DEPARTMENT OF ENVIRONMENTAL MANAGEMENT  
OFFICE OF WATER RESOURCES  
FRESHWATER WETLANDS PERMIT  
APPROVED WITH CONDITIONS AS SPECIFIED IN THE LETTER OF DATED JUN 20 2014 FILE # 14-0047  
NO CHANGES ALLOWED WITHOUT PRIOR APPROVAL  
APPROVED PLANS MUST BE AT CONSTRUCTION

PROPOSED OWTS NEW CONSTRUCTION PLAN  
PREPARED FOR  
**KEVIN ROGERS**  
PLAT 605 LOT 119  
299 NARROW AVENUE  
TIVERTON, RHODE ISLAND

SHEET 1 OF 2 JOB#: 03-048

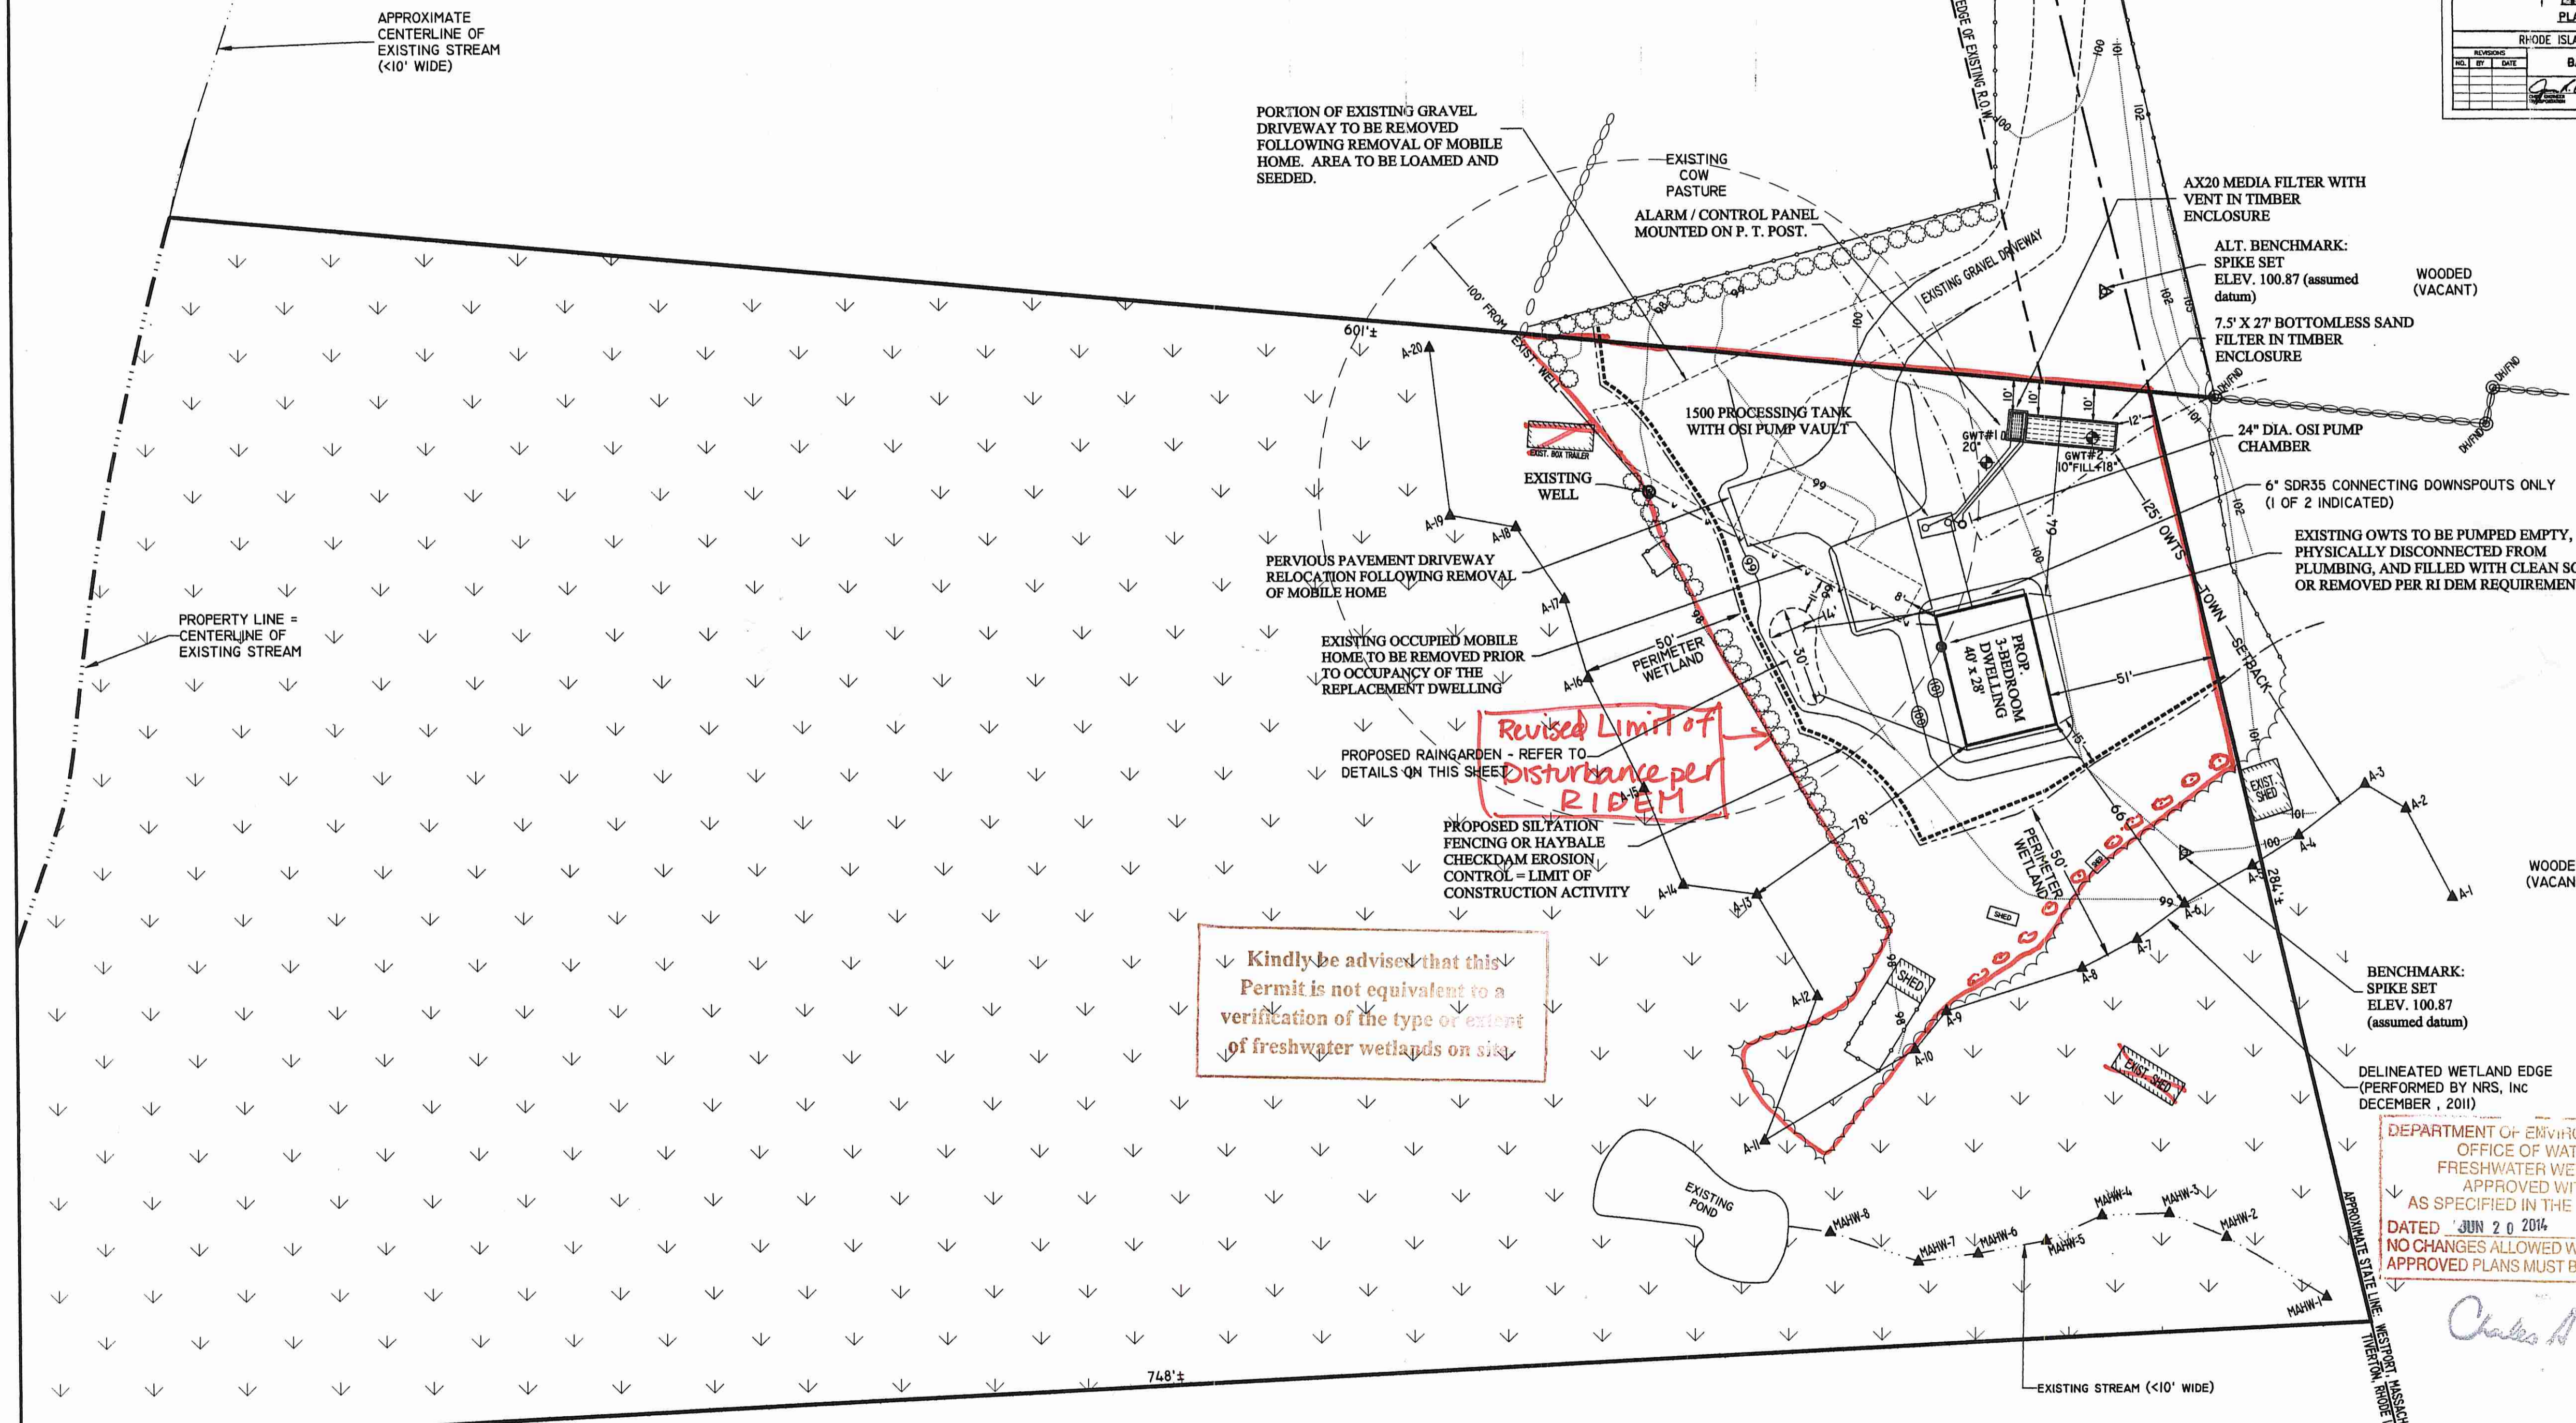
Revised Limit of Disturbance per RIDEM

plantings per Condition No. 16(b) of the permit letter.
